**OVERLAND FLOW
PROPOSED SUB DIVISION
337 LOWER PLATEAU RD
BILGOLA PLATEAU**

ADDENDUM TO THE
FLOOD INUNDATION & RISK ASSESSMENT REPORT
PROPOSED SUB DIVISION
337 LOWER PLATEAU RD BILGOLA PLATEAU
DATED MARCH 2023 AND ADDENDUM DATED 25. 03. 2024
BY BARRENJOEY CONSULTING ENGINEERS PTY LTD

**Job No 211203
Jul 2024
Prepared by
Lucas Molloy
BE CPEng NER**

Appendix C
Site, House 1, House 2, House 3 and Driveway
Flood Assessment
(Barrenjoey Consulting Engineers Pty Ltd)

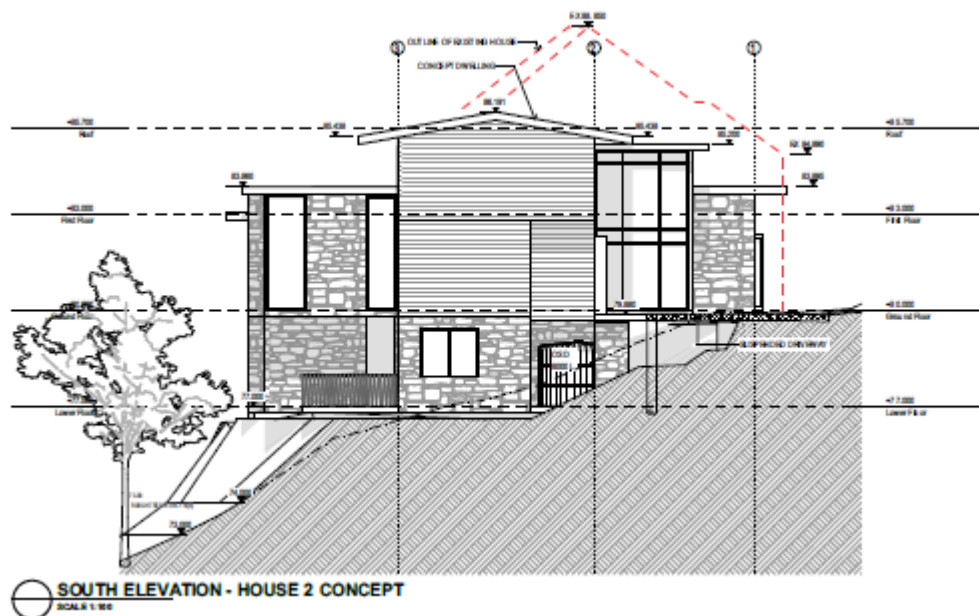
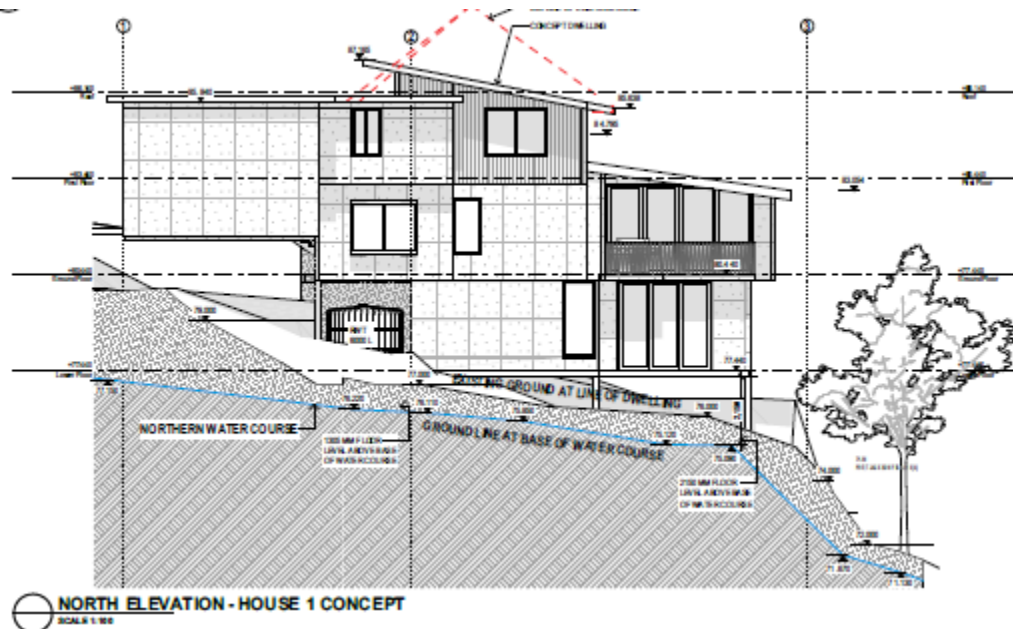
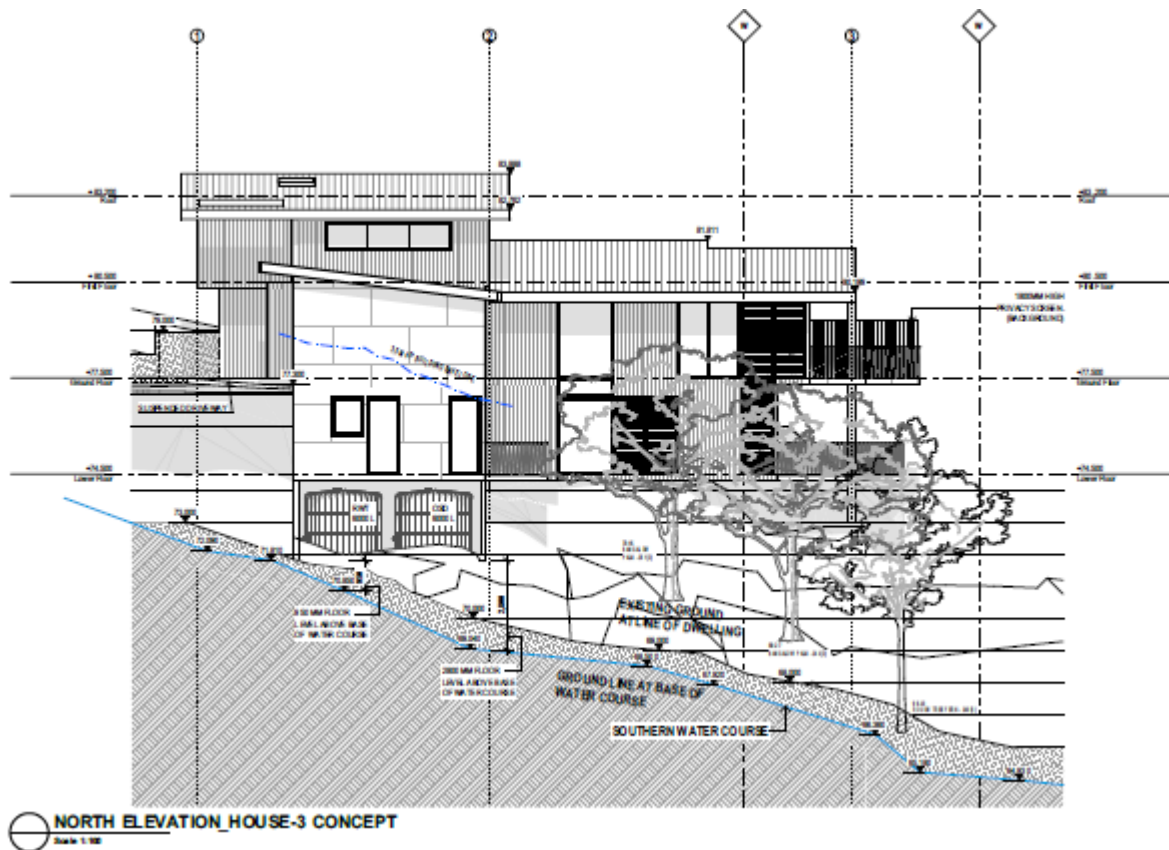
5) As the property is impacted by overland flow Barrenjoey Consulting Engineers has summarised the flood information in terms of 1/100 AEP and FPL levels throughout the development site from Councils Avalon to Palm Beach Floodplain Risk Management Study and Plan 2017 as prepared by Manly Hydraulics Lab. However, no assessment has been made as requested in the previous development application in terms of whether the proposed dwellings have habitable floors with a minimum of 500mm freeboard to the 1/100 AEP overland flow path levels. Additionally, an assessment is to be made on the proposed location of the internal access road and the existing overland flow paths that impact the site.

The primary risk relevant to stormwater flow on the development site is the natural watercourse/s traversing the site from east to west. As per our previous analysis (refer Appendix C and Appendix D) these watercourses are significantly defined within steep edged “gullies”, with depths of flow (in the vicinity of the proposed residences) during the 1/100 AEP event of between 130 and 220mm (refer Appendix B).
